Form 3160-5
(June 2019)UNITED STATES
DEPARTMENT OF THE INTERIOR
BUREAU OF LAND MANAGEMENTFORM APPROVED
OMB No. 1004-0137
Expires: October 31, 2021**SUNDRY NOTICES AND REPORTS ON WELLS**
Do not use this form for proposals to drill or to re-enter an abandoned well. Use Form 3160-3 (APD) for such proposals.

8. Well Name and No. ROSS DRAW 17 FED COM/705H

9. API Well No. 30-015-47728

EOG respectfully requests an amendment to our approved APD for this well to reflect the following changes:

Revised Wellbore

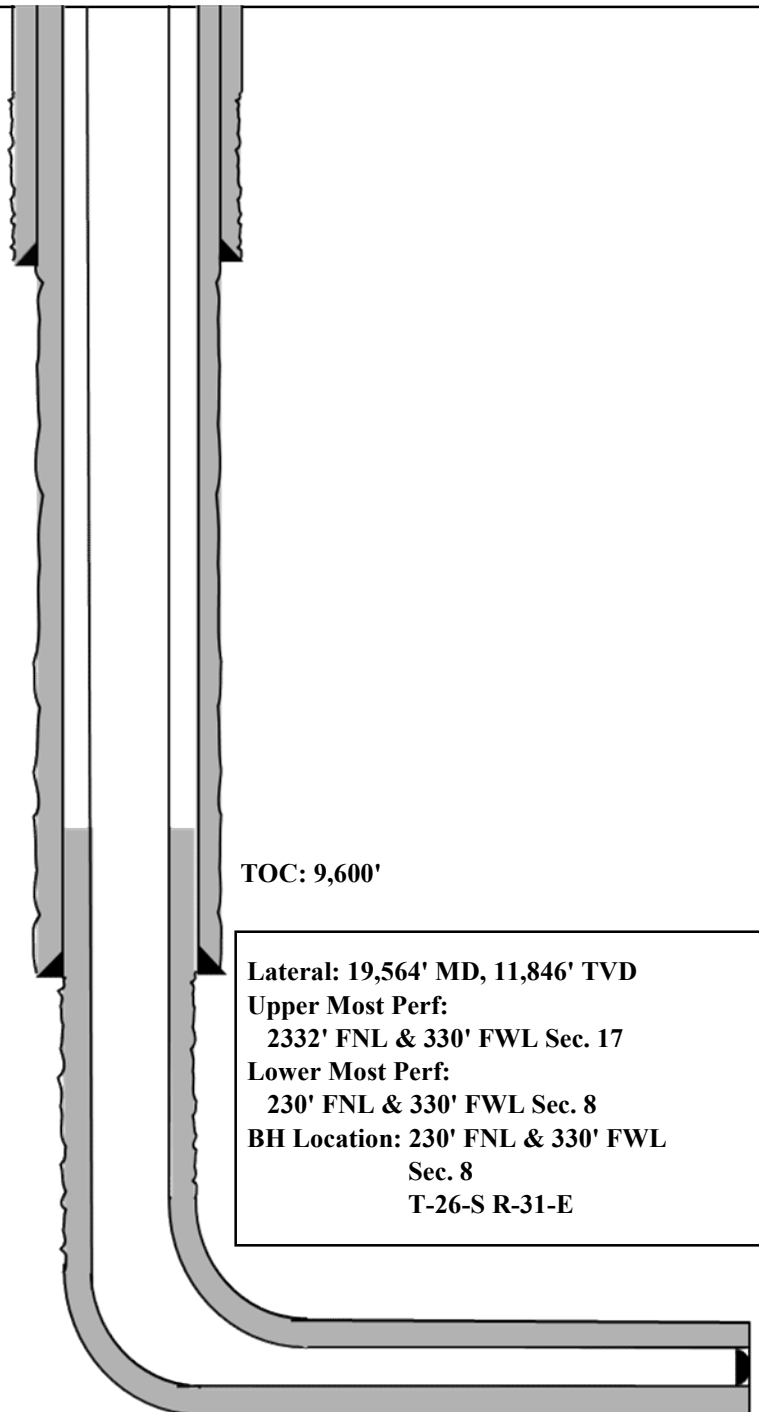
Bit Size: 8-3/4"
7-5/8", 29.7#, HCP-110, FXL,
@ 0' - 10,100'

Bit Size: 6-3/4"
5-1/2", 20#, P110-EC, DWC/C IS MS,
@ 0' - 9,600'

5-1/2", 20#, P110-EC, Vam Sprint SF,
@ 9,600' - 10,100'

5-1/2", 20#, P110-EC, DWC/C IS MS,
@ 10,100' - 19,564'

KOP: 11,386' MD, 11,368' TVD
EOC: 12,136' MD, 11,846' TVD

Figure 1: Cameron TA Plug and Offline Adapter Schematic

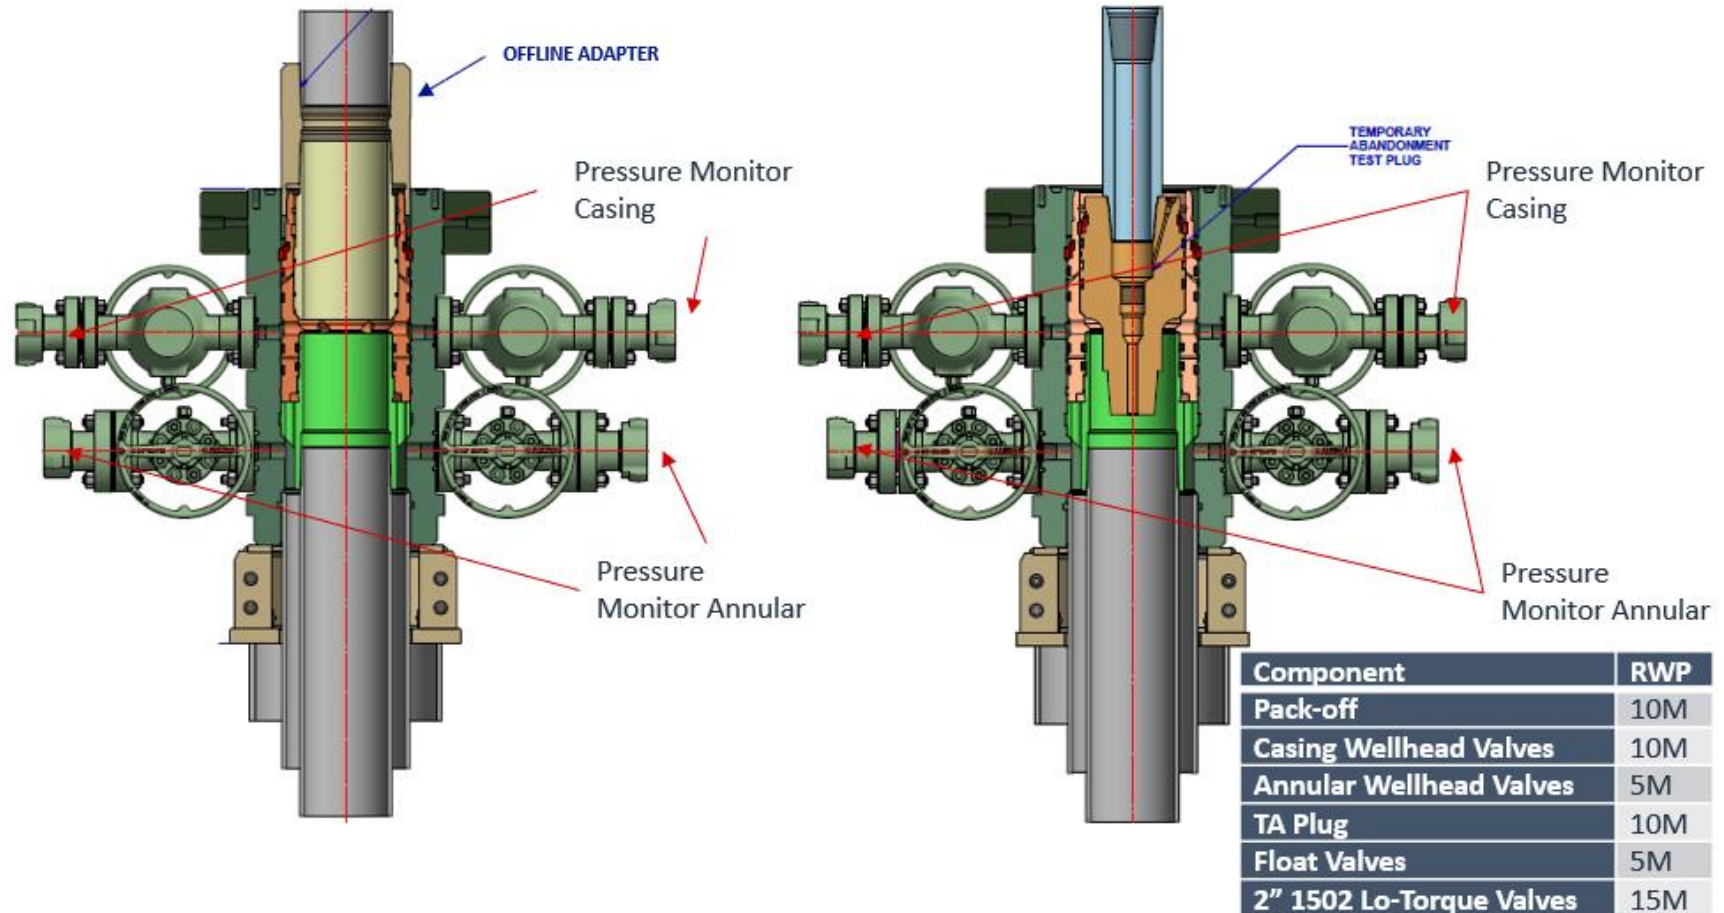
- c. Return line schematics can be seen in Figure 3.
10. Remove TA Plug from the casing.
11. Install offline cement tool.
 - a. Current offline cement tool schematics can be seen in Figure 1 (Cameron) and Figure 2 (Cactus).

Figure 4: Rig Placement Diagram

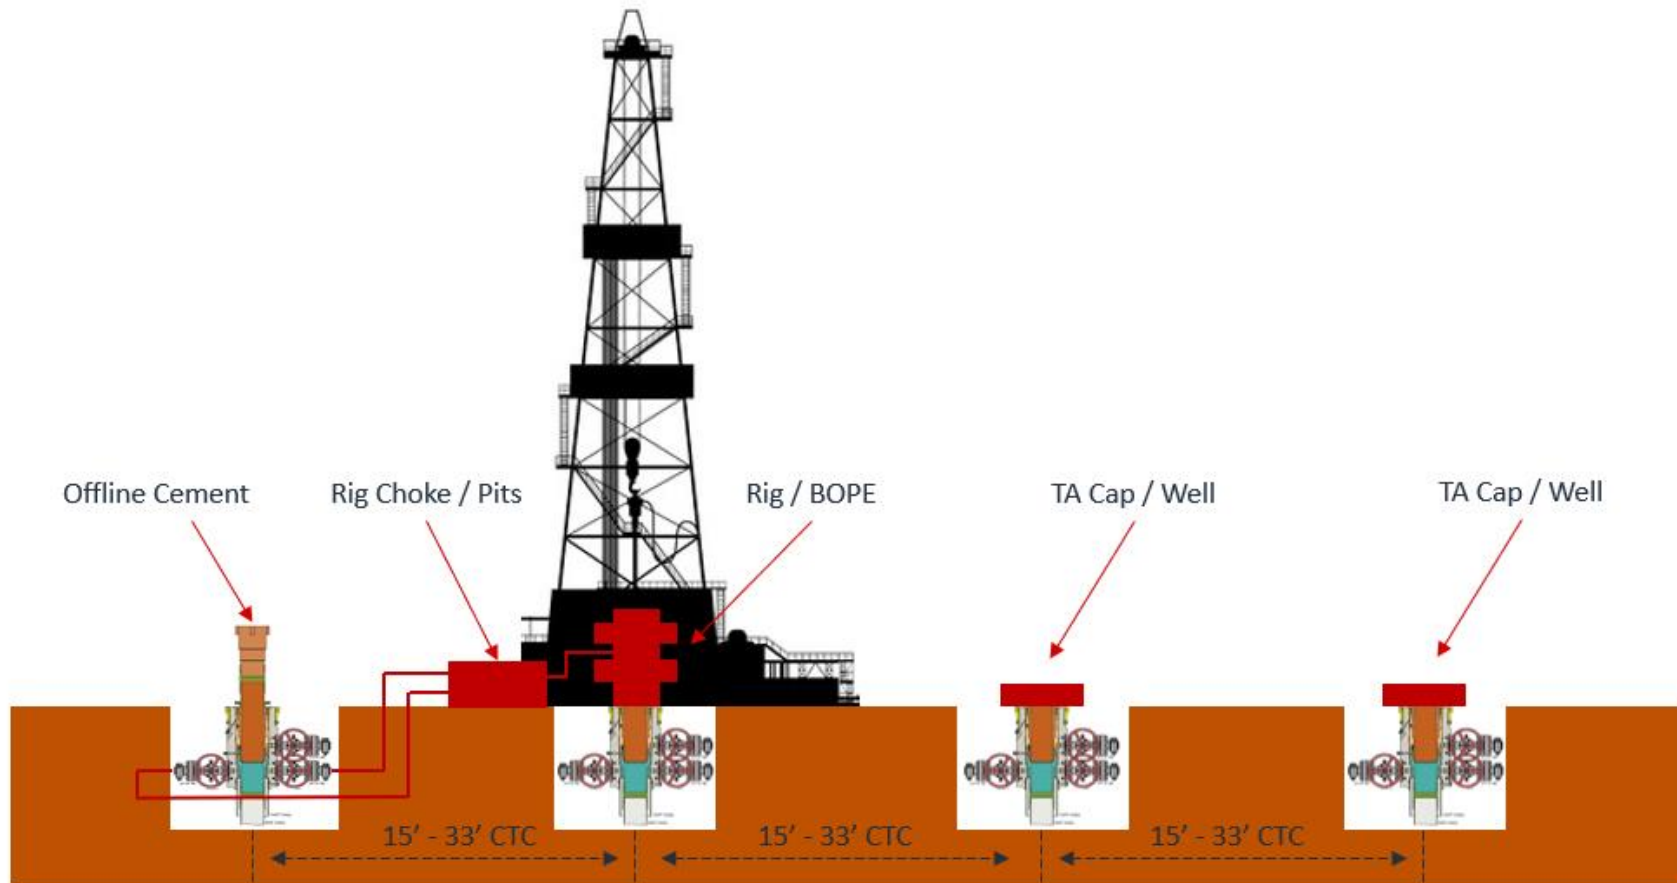
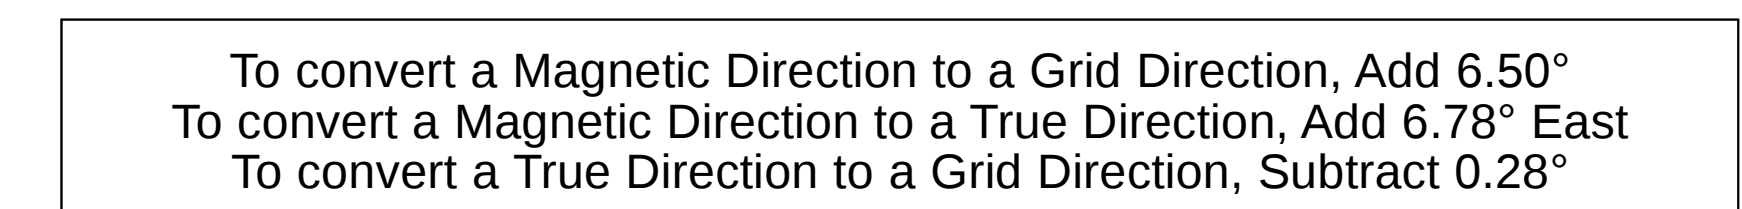
- e. Diagram for rig positioning relative to offline cementing can be seen in Figure 4.
9. Rig up return lines to take returns from wellhead to pits and rig choke.
